MIL-M-28787/303A(SH)
AMENDMENT 2
6 January 1992
SUPERSEDING
AMENDMENT 1
8 July 1983

# MILITARY SPECIFICATION

## MODULES, STANDARD ELECTRONIC

## MEMORY, RANDOM ACCESS, KEY CODE ZJT

FIGURE 22. Dynamic test circuit for table XVI.

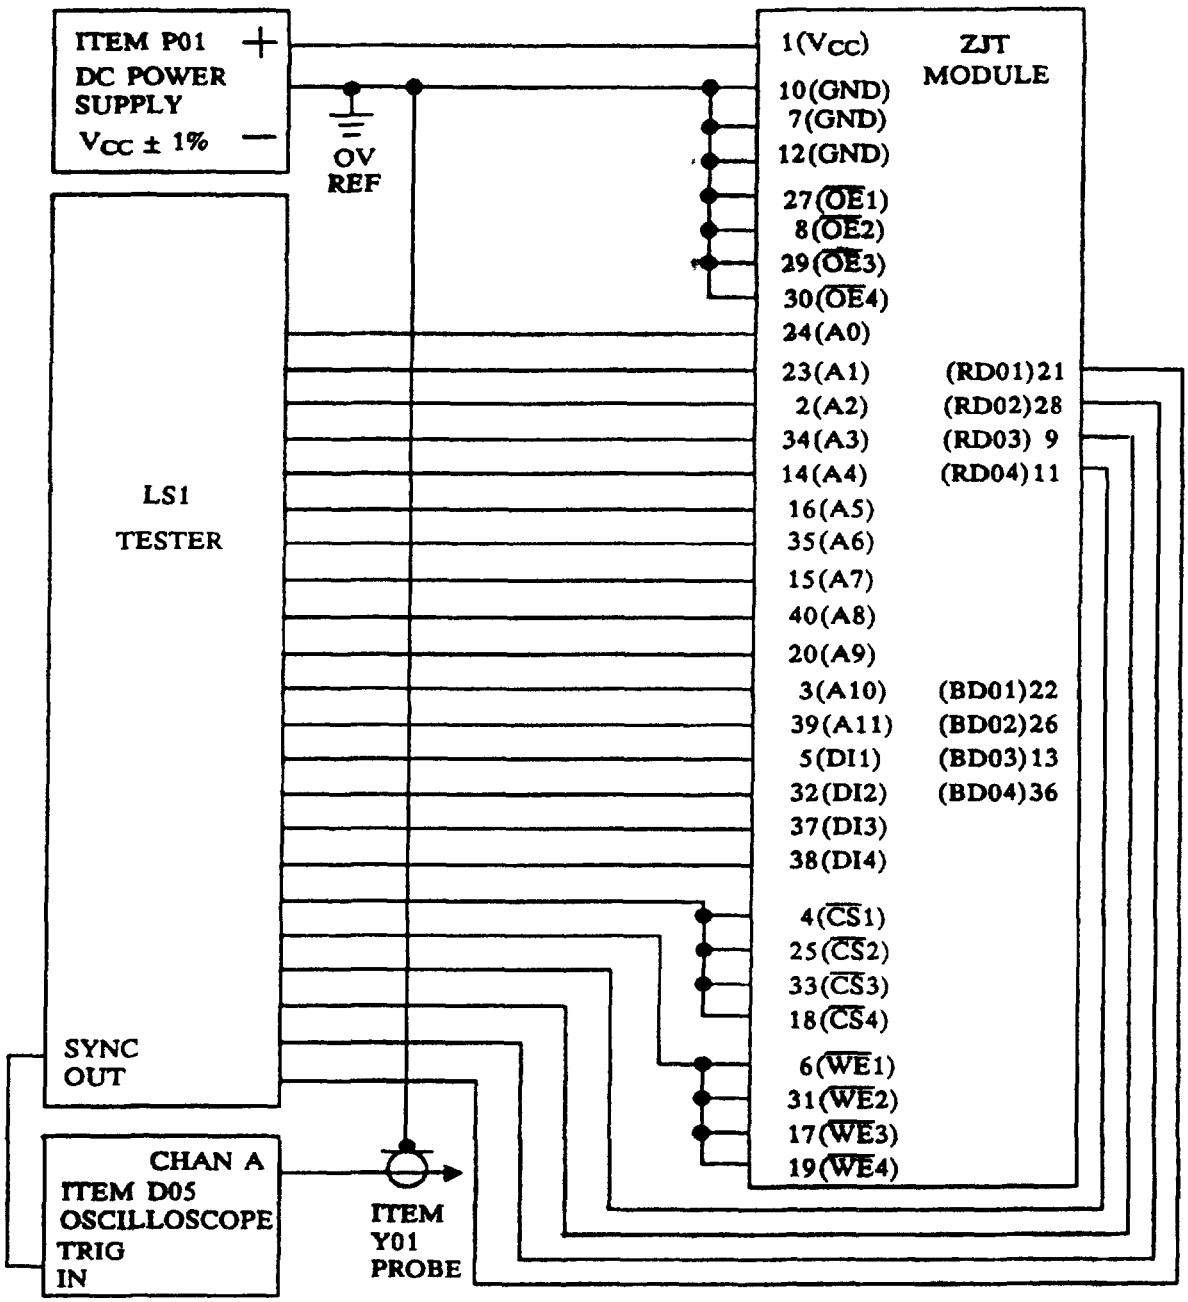
FIGURE 22: Delete and substitute new figure 22 as printed on page 5 of this amendment

NOTES:
1. $V_{CC}$ = 4.5V ± 1% for test conditions R1, R3, R5, R7, R9, R11, R13, and R15.
2. $V_{CC}$ = 5.5V ± 1% for test conditions R2, R4, R6, R8, R10, R12, R14, and R16
3. Load output pins 9, 11, 21, and 28 with load as specified on figure 14 with $C_L$ = 50pF for test conditions R1-R8.
4. Load output pins 9, 11, 21, and 28 with load as specified on figure 14 with $C_L$ = 150pF for test conditions R9-R16..
